Project No. 2333-094 – Maine
Rumford Falls Hydroelectric Project
Rumford Falls Hydro LLC

**Reference: Determination on Requests for Study Modifications for the
Rumford Falls Hydroelectric Project**

Figure 1: Location of project features and Impoundment Trophic State Study sampling locations.

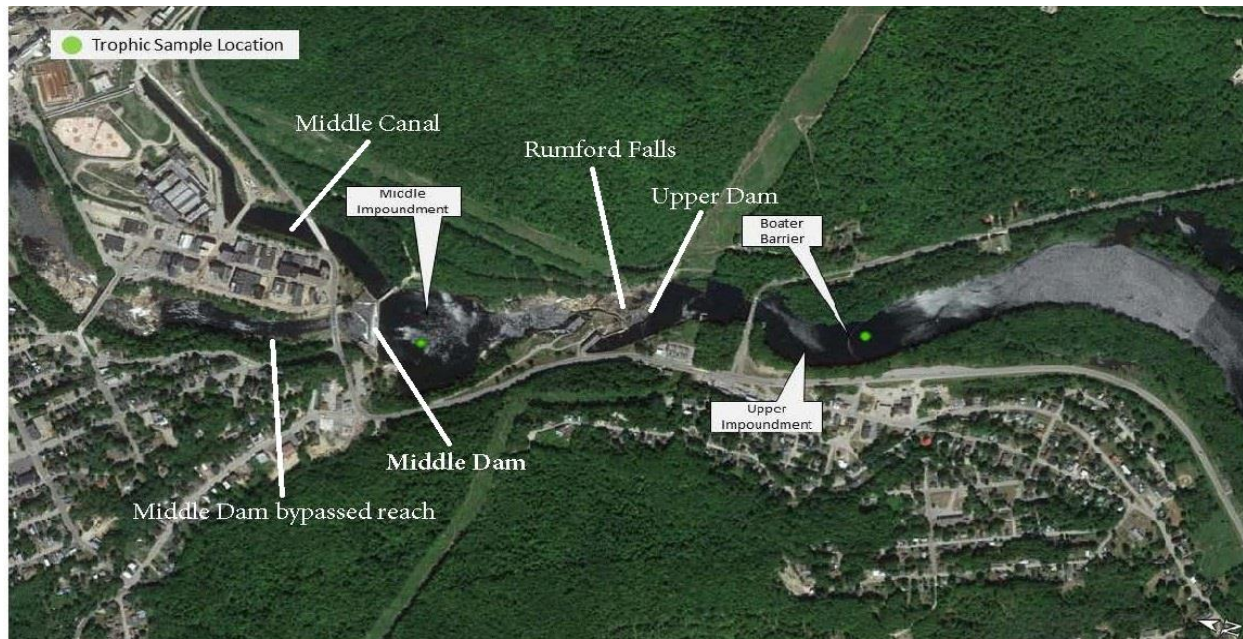
The conservation groups request that Rumford Falls Hydro collect secchi disk depth, temperature, DO, total phosphorous, chlorophyll a, color, pH, and total alkalinity data from the Middle Canal. The conservation groups argue that the Middle Canal is a separate impoundment with different characteristics than the Upper and Middle Dam impoundments where the other samples were taken. They state that the data are required to determine the trophic state of all impounded waters and would identify stratification effects on the dissolved oxygen within the Middle Canal.

The Middle Dam impoundment trophic water quality sampling site is less than 1,000 feet upstream from the Middle Canal sampling site recommended by the conservation groups; the temperature and DO samples taken at the lower powerhouse intake is about 1,000 feet downstream of the conservation groups recommended sampling site. The water quality data collected in the impoundment and at the lower powerhouse intake show little difference. Impoundment temperatures ranged from 18 to 25° C; intake temperatures ranged from 13 to 26° C. DO ranged from 7 to 11 mg/L in the impoundment and from 7 to 10 mg/L at the intake. Therefore, we do not expect any difference in the water quality as water flows through the canal. Because the existing information is representative of conditions at the conservation group's requested additional site and sufficient to characterize water quality conditions in the project's impoundments (section 5.9(b)(4)), we do not recommend requiring Rumford Falls Hydro to conduct additional trophic water quality sampling in the Middle Canal as requested by the conservation groups.
